Henbury Parish Council: Key Points of Objection to 19/5582M

Actual SBI layout (left, green line) and masterplan (right, SBI in grey). The blue line added on the right is a closer representation of the SBI boundary and this should be followed in the design with added 3m buffer, else the SBI is compromised.

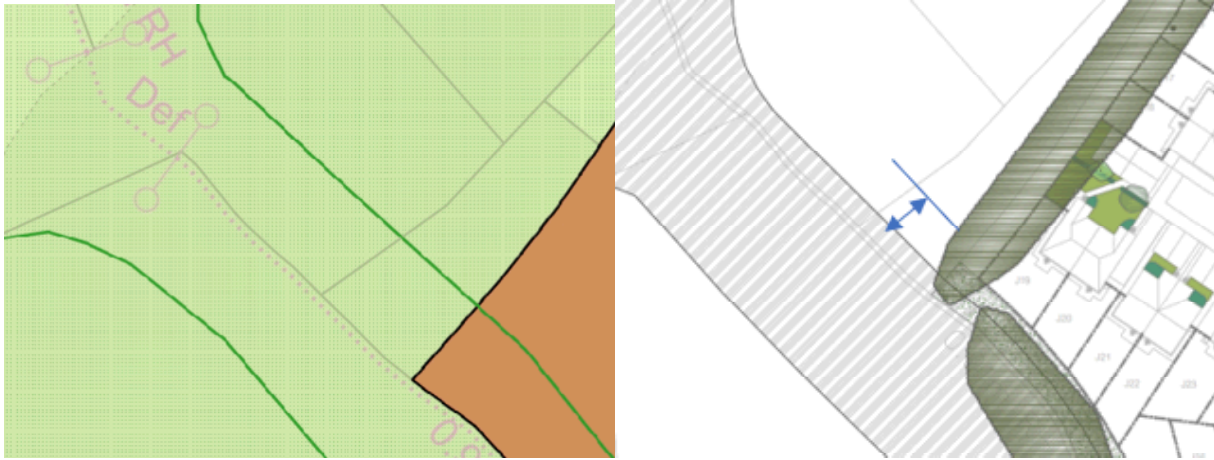
The latest masterplan, while purporting to allow a 3m buffer around the SBI, actually appears to allow a reduction in its size. Comparison of the below images shows the effect most prevalent around the northern pond in the images where the area of marshy grassland within the SBI is reduced.

We therefore request that CEC closely review all the proposed changes around the SBI and ensure that any plans do not reduced its size, or content, but instead increase the size via the agreed buffering.
